*Ventura Countywide  
Stormwater Quality  
Management Program*

May 27, 2008

**SUBJECT: DRAFT TENTATIVE ORDER OF THE VENTURA COUNTY MUNICIPAL SEPARATE STORM SEWER SYSTEM PERMIT (NPDES No. CAS004002) FOR THE VENTURA COUNTY WATERSHED PROTECTION DISTRICT, COUNTY OF VENTURA AND THE INCORPORATED CITIES**

Table 2.

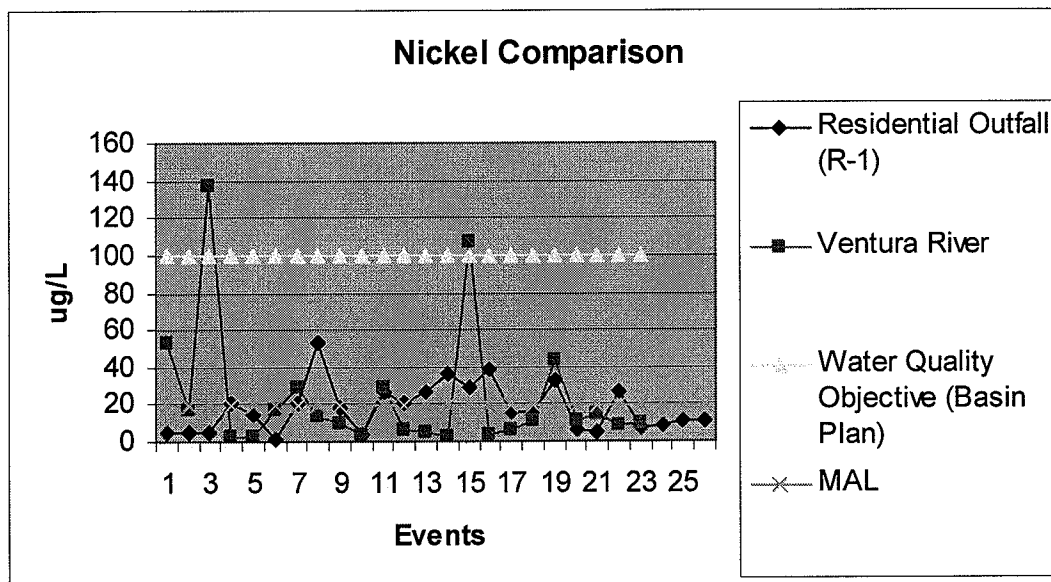
Ventura County are out of compliance with the nickel MAL (see above Table 1), but not necessarily with the applicable water quality objective. In sum, the waterbodies exceed the MALs even though they comply with the applicable water quality objective that supports beneficial uses. Consequently, the Permittees will be found to be out of compliance with the MEP standard even though they are not causing or contributing to an exceedance of an applicable water quality standard. A plot of monitoring data for the Ventura River (of which the watershed is only 3% developed) and a residential outfall as compared to the MAL, and the water quality objective is shown in Table 2 below.

A closer review of Table 2 shows the Ventura River is substantially in compliance with the water quality objective in the Basin Plan but not the MAL. Furthermore, because the waterbody is primarily in compliance with the applicable water quality objective, discharges from residential storm drain outfalls are clearly not causing or contributing to an exceedance of a water quality standard. Thus, the MS4 discharges and the waterbody do not exceed or impact the Basin Plan water quality standards, but due to the application of the MAL, the Permittees would be out of compliance with the Draft Tentative Order and would potentially be subject to mandatory minimum penalties for failing to comply with an effluent limitation.

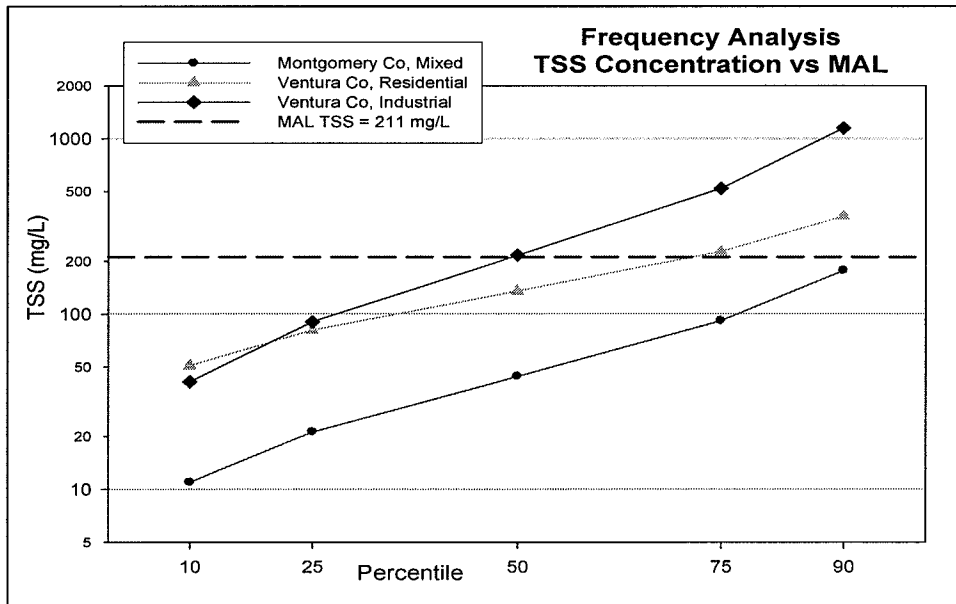
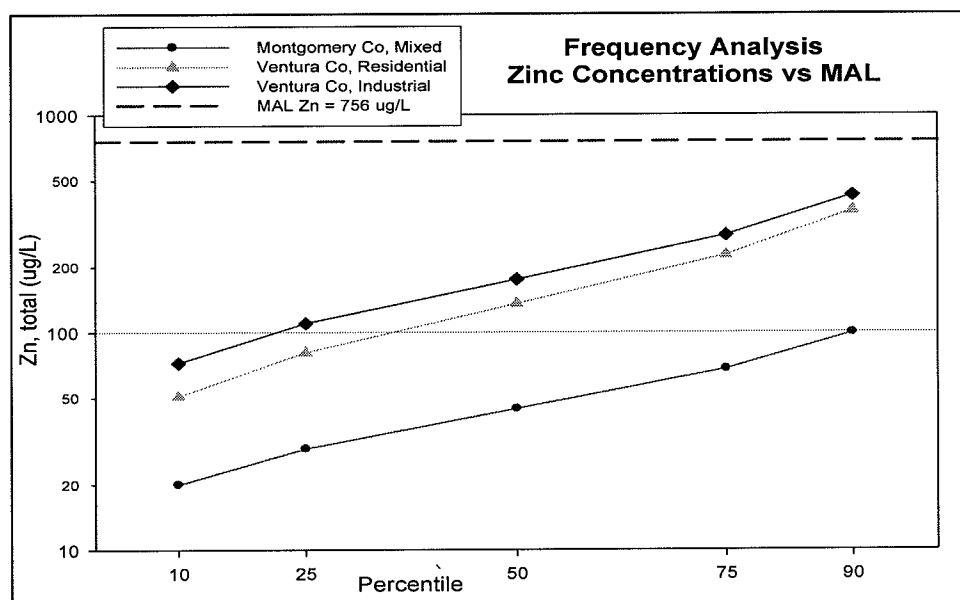
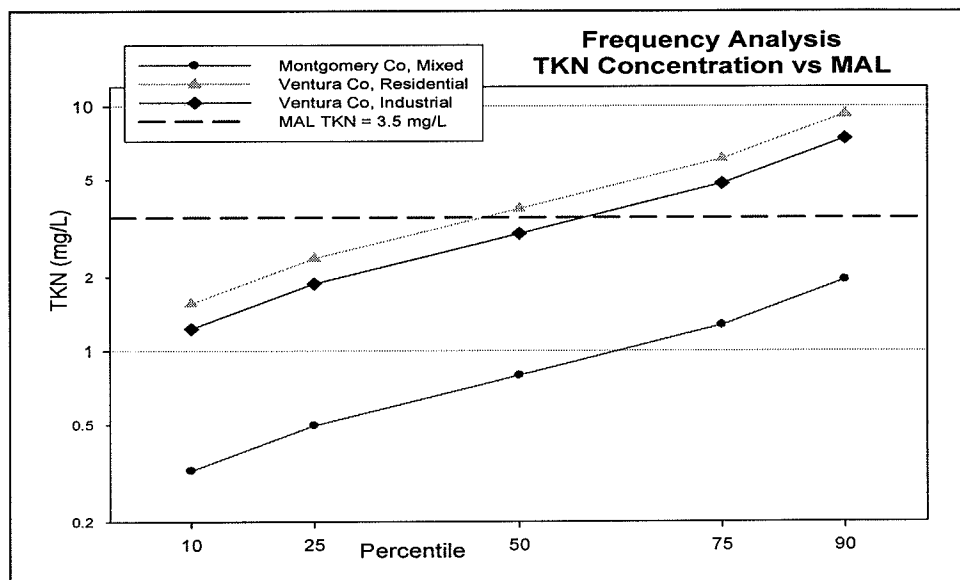
Both programs have long-term monitoring programs including characterization of discharges. A side-by-side comparison of the monitoring results of selected constituents common to both programs is shown in the following frequency distribution graphs. The proposed MALs are also included in the graphs.

A review of the graphs clearly shows that the runoff from the Montgomery area is of better quality than the runoff from Ventura County. The reason for this difference is not due to a difference in stormwater management program implementation but rather to the difference in annual precipitation. Both programs have similar implementation efforts and the outfalls examined in each program are similar in characteristics. The year-round distribution of rainfall on the east coast mitigates the build-up and wash-off of pollutants. This may be shown another way by calculating the differences in the runoff means and comparing that difference with the inverse difference in rainfall; in other words, the pollutant concentration is inversely related to the amount of rainfall.
